Woodland Recreation / Community Club

Accessibility Review

Woodland Recreation / Community Center
Lower Level
City of Duluth, MN

Woodland Recreation / Community Center
Upper Level
 City of Duluth, MN

Photo 2: Enlarge the concrete pad to provide maneuvering clearance at the community room entry.

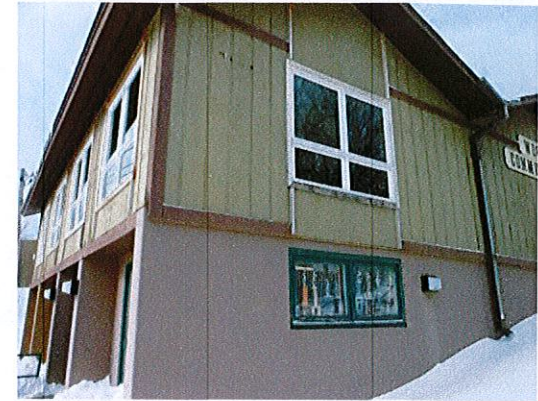
| Location | Solution / Comments | Qty | Unit Cost | Total Cost | Priority | Estimated Compl. Date | Person Responsible | Actual Compl. Date | Actual Cost |
|--|--|-----|-----------|---------------------------|-----------------|--------------------------|-----------------------|--------------------------|----------------|
| 12B1 | 15611 Extend sidewalk to provide appropriate maneuvering clearance on the latch side of the door. ICC / ANSI 404.2.3.1 <i>Currently provides 13". Photo 2.</i> | 1 | \$500 | \$500 | 2 | | | | |

Photo 3: The WAHA uses the upper level community room as a lounge. There is not currently an accessible route between the upper and lower (warming house) level.

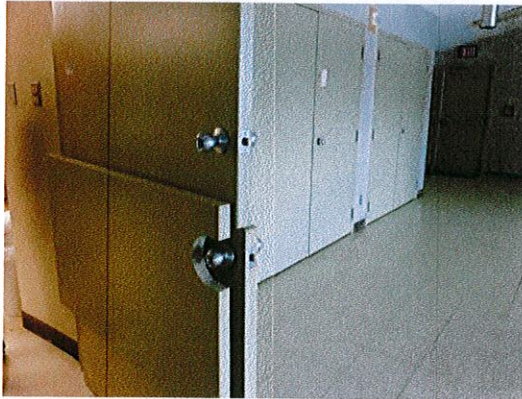
| Location JQP # / Item # | Solution / Comments | Qty | Unit Cost | Total Cost | Priority | Estimated Compl. Date | Person Responsible | Actual Compl. Date | Actual Cost |
|---|---|-----|-----------|---------------------------|------------------|--------------------------|-----------------------|--------------------------|----------------|
| 14D1 15618 | Provide a fully compliant elevator to provide access between levels. MN 1341 1104.4 and 402.2 <i>There is not currently an accessible route between the upper level and lower level warming house. The upper level community room is used as a player and family lounge. Photo 3.</i> | 1 | \$250,000 | \$250,000 | 3 | | | | |

Photo 6: Create wheelchair viewing positions on the gymnastics floor (because there is not an accessible route to the viewing loft).

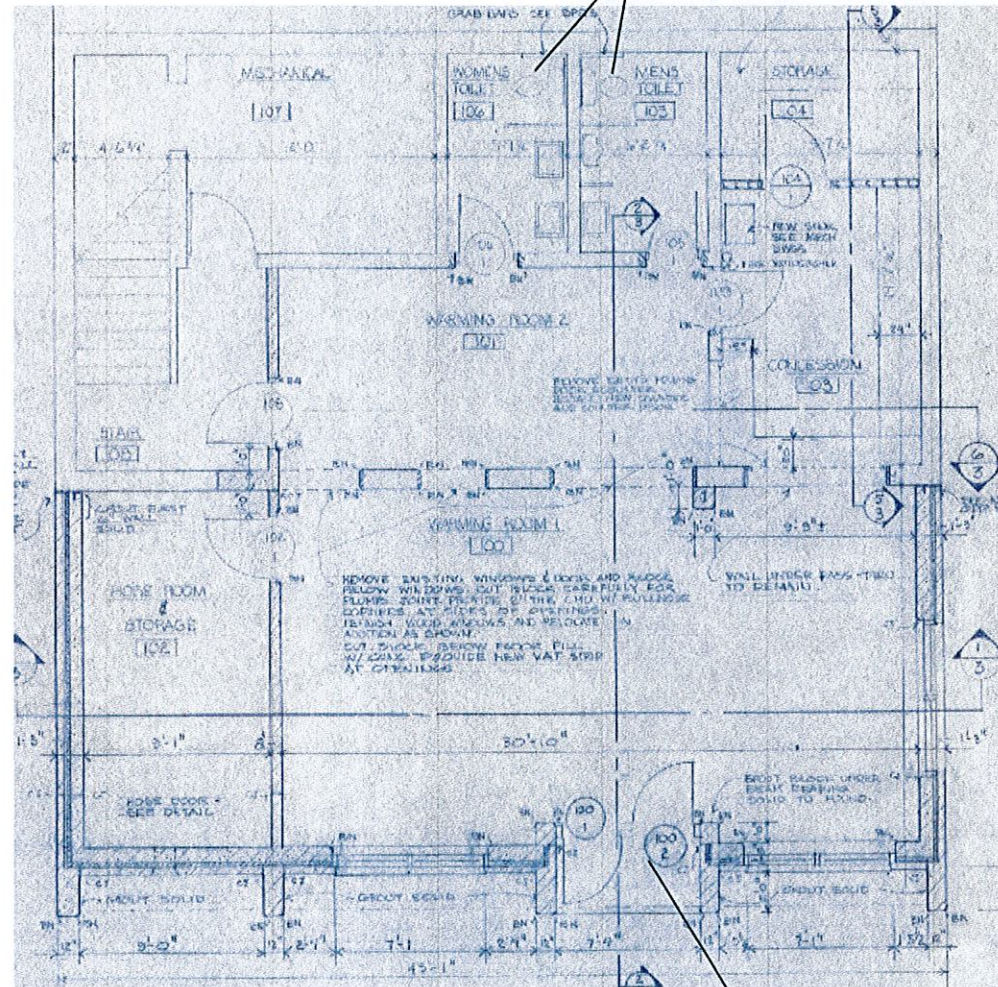
| Location | Solution / Comments | Qty | Unit Cost | Total Cost | Priority | Estimated Compl. Date | Person Responsible | Actual Compl. Date | Actual Cost |
|------------------------|---|-----|-----------|---------------------------|------------|--------------------------|-----------------------|--------------------------|----------------|
| 14D2 15617 | Relocate program as necessary to an accessible location to provide program access. MN 1341 1104.4 <i>There is not currently an accessible route to the viewing balcony. Identify a location on an accessible route for a wheelchair position that will allow viewing of the various events. Photos 5 and 6.</i> | 1 | \$0 | \$0 | 1 | | | | |

Photo 5: A small viewing loft is provided in the gymnastics area. There is not currently an accessible route. Add handrails at the stairs.

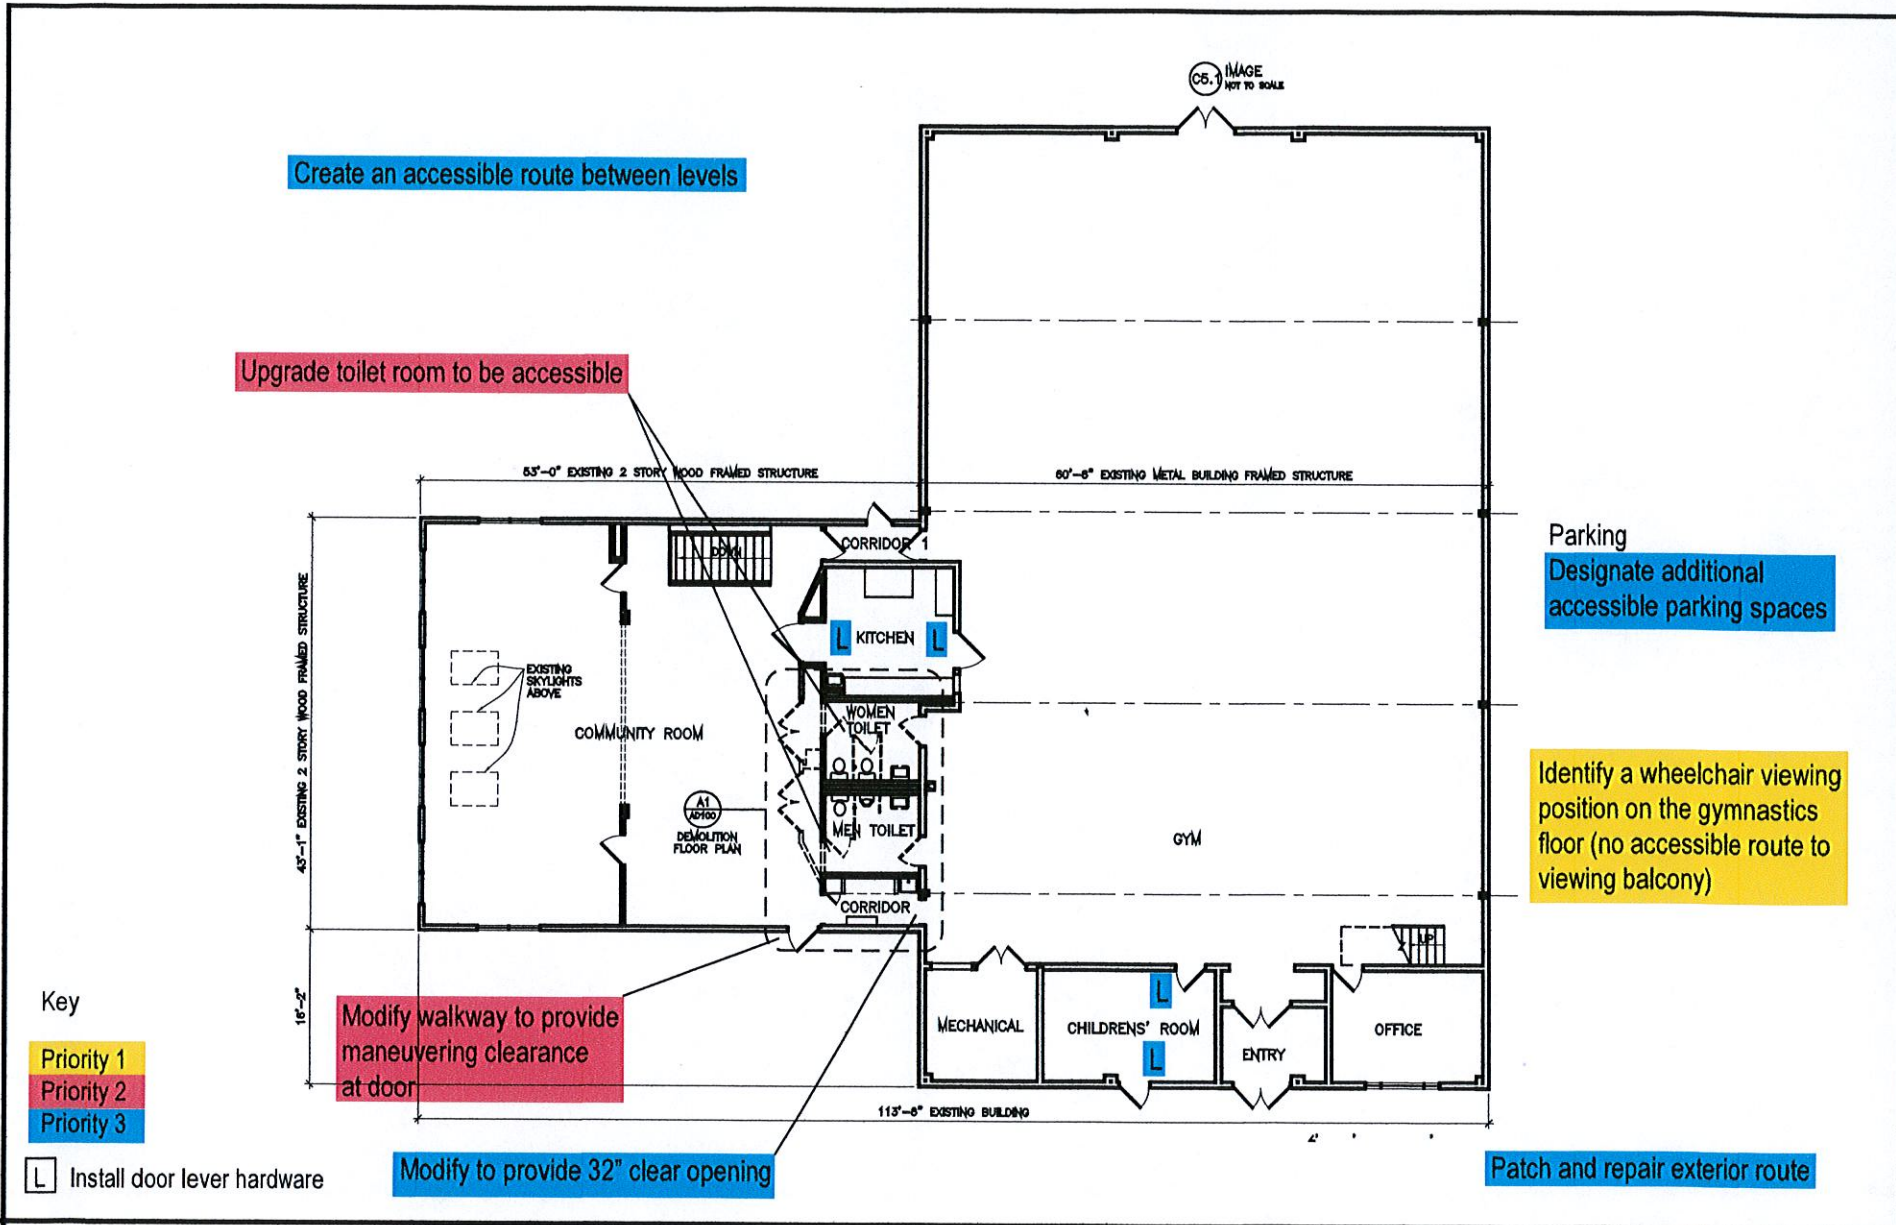
Remove partitions and create single user

Bevel threshold

[L] Install door lever hardware
